Service Bulletin

Bulletin Number: **SB-20-333-1 Revision B (1 of 2 Bulletins)**
Release Date: **December 29, 2020**
Distribution: **Heil Dealers, Heil Customers, Heil Technical Services, Heil Customer Care**
Subject: **Half/Pack® and Half/Pack® (Featuring Odyssey® Controls): Front Head Manifold Hydraulic Tube Failures**

Figure 1. Front Head Tube Support Clamp Field Kit (372-9225) Installation Location

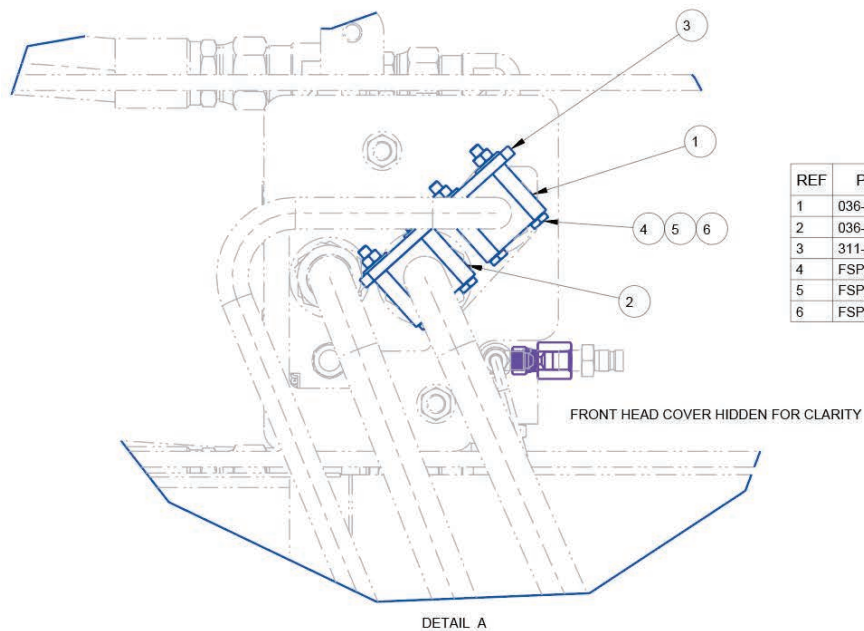
Certain Heil Half/Pack® and Half/Pack® (featuring Odyssey® Controls) units manufactured between **October 1, 2018 through July 31, 2020** identified below can potentially have specific hydraulic tube failures due to tube misalignment and insufficient tube clamping force to prevent tube damage from vibration.

This Service Bulletin describes the required interim corrective action procedure to install the Front Head Tube Support Clamp Field Kit (372-9225). This kit decreases hydraulic tube vibration and reduces the chance of front head manifold tube movement. Reinforcing the 3/4" Hydraulic Tube (354-5571) will prevent the tube from loosening or breaking at the front head manifold.

- (1) Enter the body through the hopper side door.
- (2) Install the Front Head Tube Support Clamp Field Kit (372-9225) as shown in **Figure 2**.

- (a) When installing Clamps (036-1597-005 and 036-1597-007) from the kit, remove the metal base plate. Front Head Tube Clamp Bracket (311-6886) is used in its place.
- (b) Replace existing hardware in clamp assembly with hardware provided in the Front Head Tube Support Clamp Field Kit (372-9225).
- (3) Exit the body through the hopper side door.
- (4) Place the unit back into service.
